The Town of Hilton Head Island
Design Review Board Regular Meeting
Tuesday, July 16, 2019 – 1:15 p.m.
Benjamin M. Racusin Council Chambers
AGENDA

Bauer and Metro
 Landscape Plan for New Sign & Back of Building
 38 A New Orleans Road Hilton Head Island SC February 2019

SITE PLAN
NORTHRIDGE PLAZA IMPROVEMENTS
 TOWN OF HILTON HEAD ISLAND, SOUTH CAROLINA
 PREPARED FOR:
GATOR NORTHRIDGE PARTNERS, LLLP

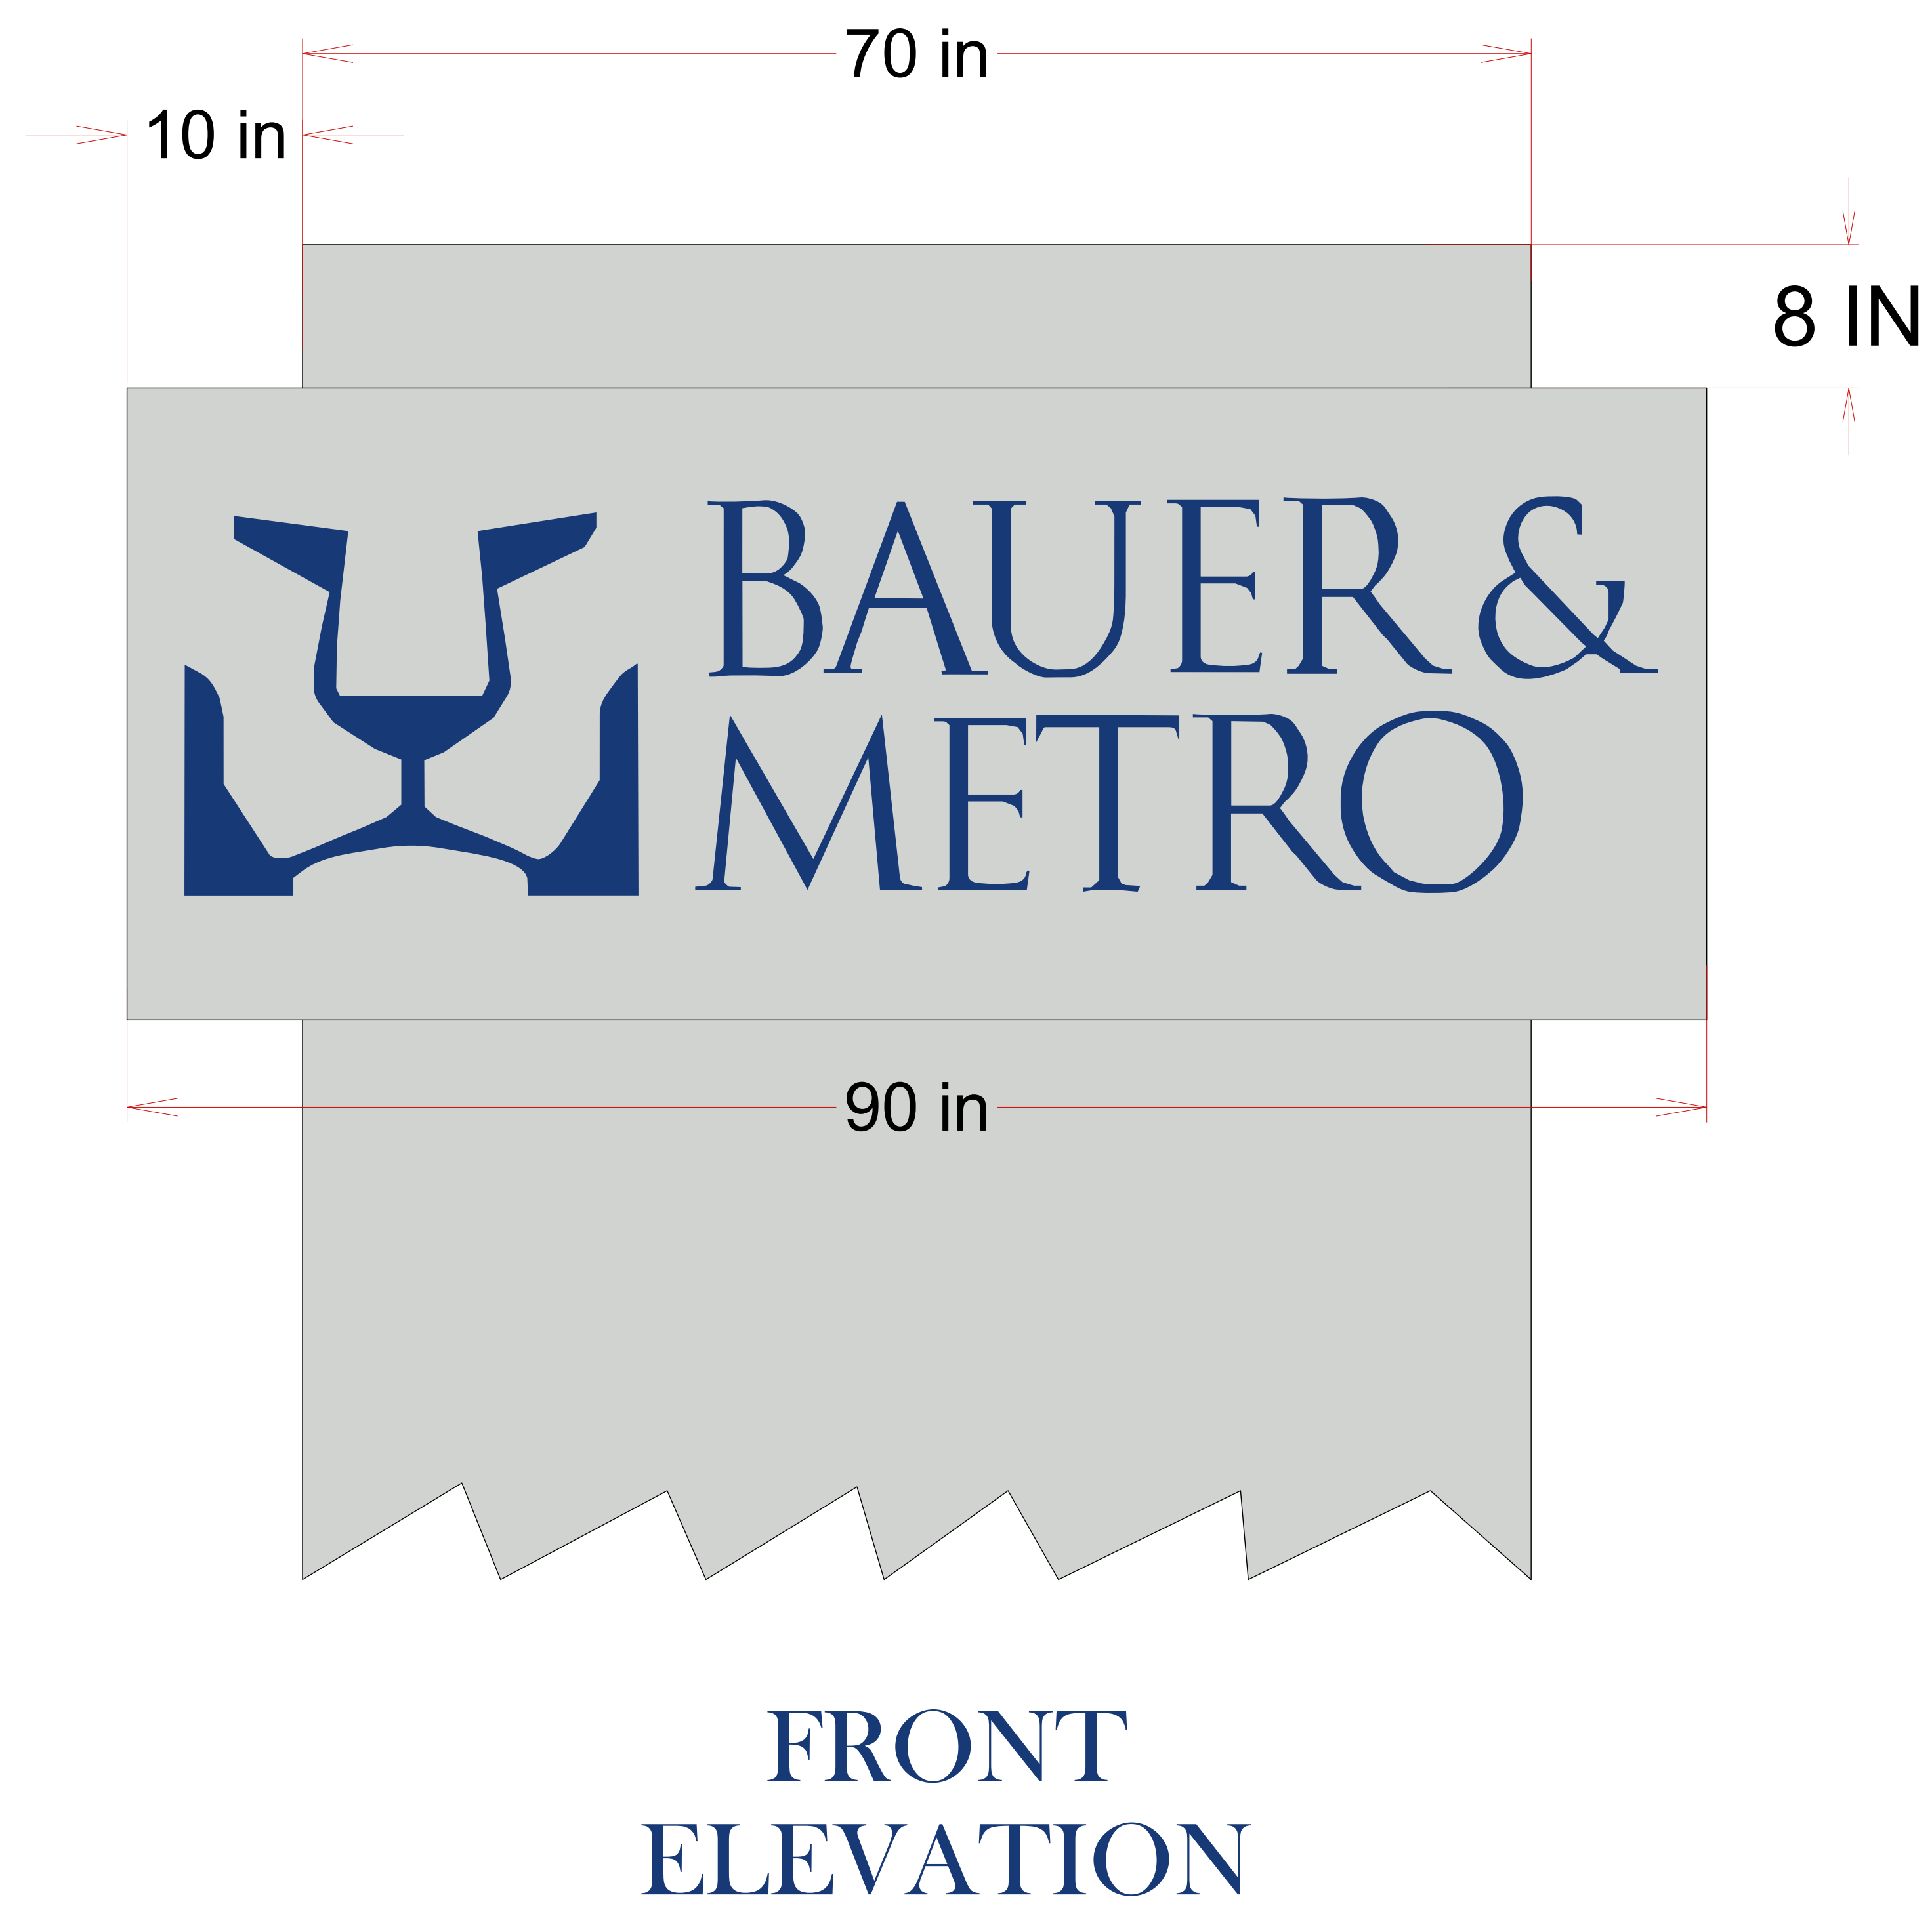
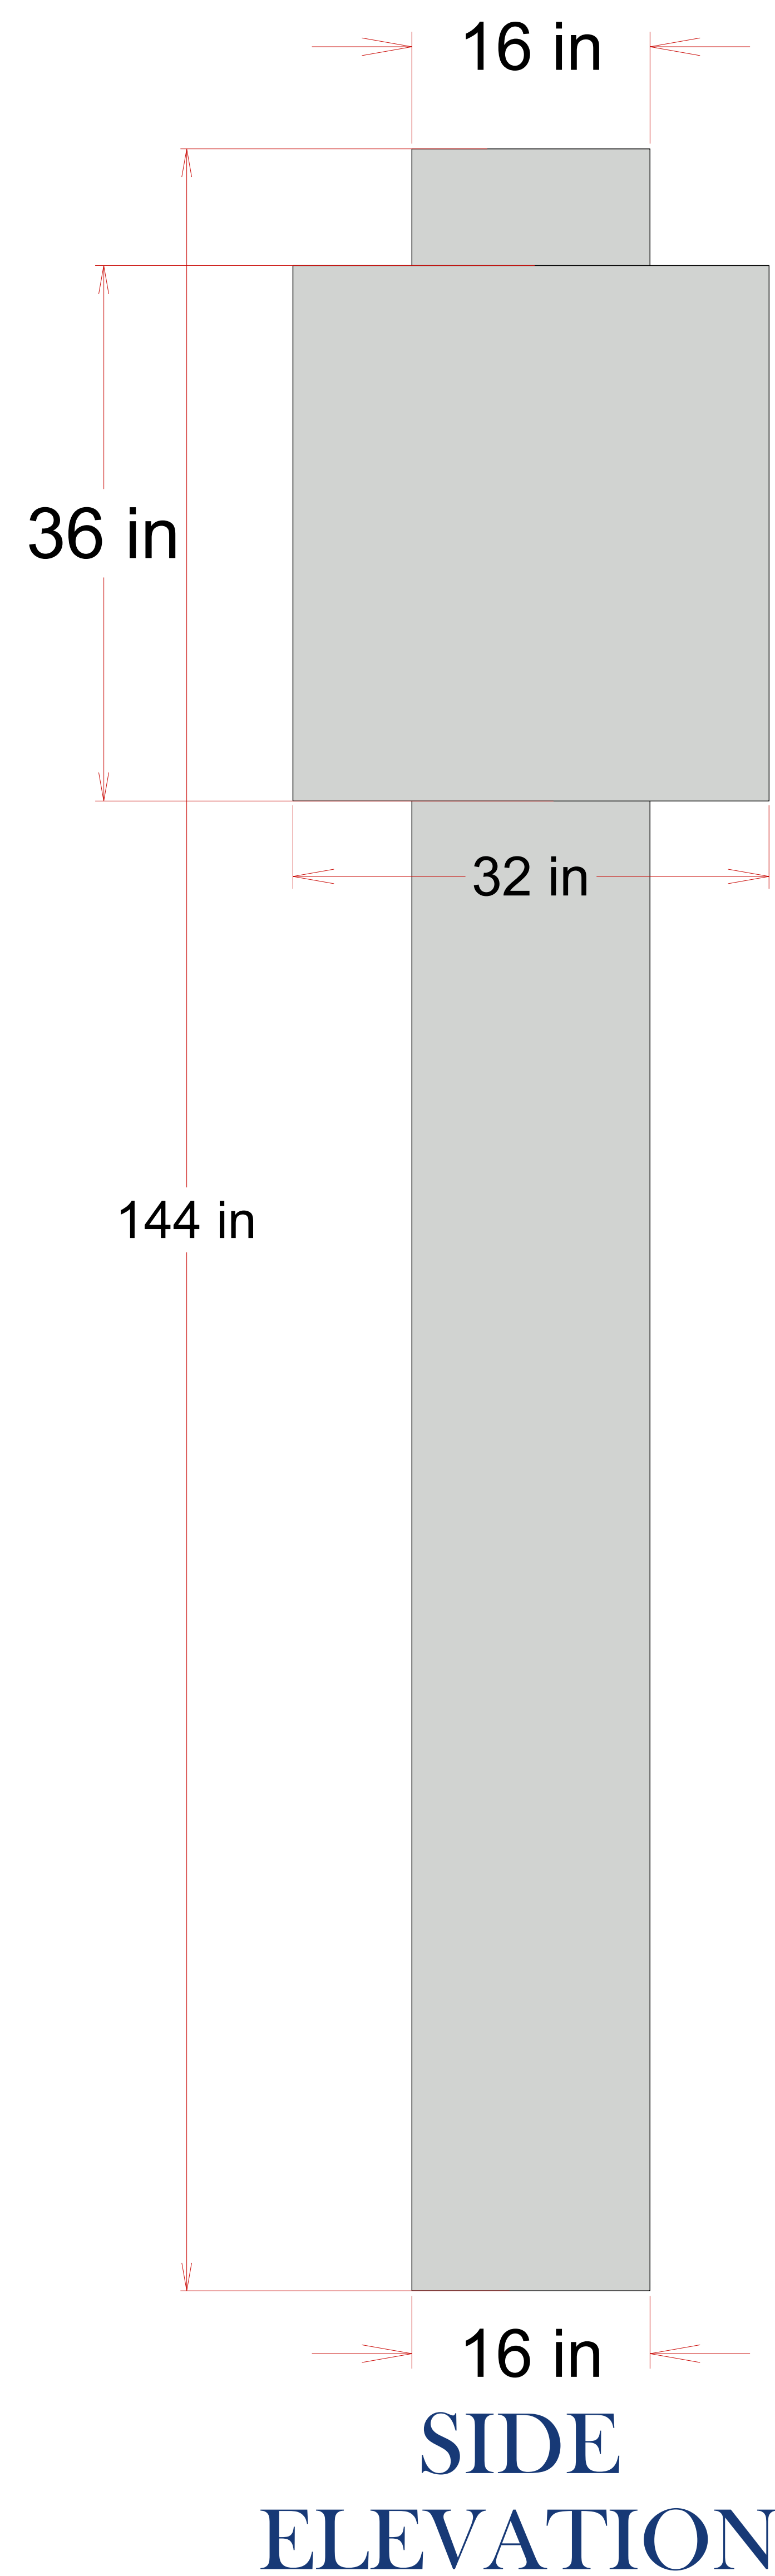
REQUIRED INFORMATION & DESIGN STANDARDS	Yes	No	N/A	Comments & Questions
The proposed landscaping matches or complements the existing vegetation on site.				<ol style="list-style-type: none"> 1. Ligustrums (Wax and Jack Frost) are exotic and invasive species and should not be used. 2. Philodendron are not native to the island, see Design Guide pages 18 thru 23 for guidance selecting plants and planting in buffers. 3. Indicate the trees that have been approved for removal in a previous Natural Resource Permit and those additional trees requested for removal on the planting plan. Show the buffer on the plans. 4. Eliminate the proposed 2’ berm.
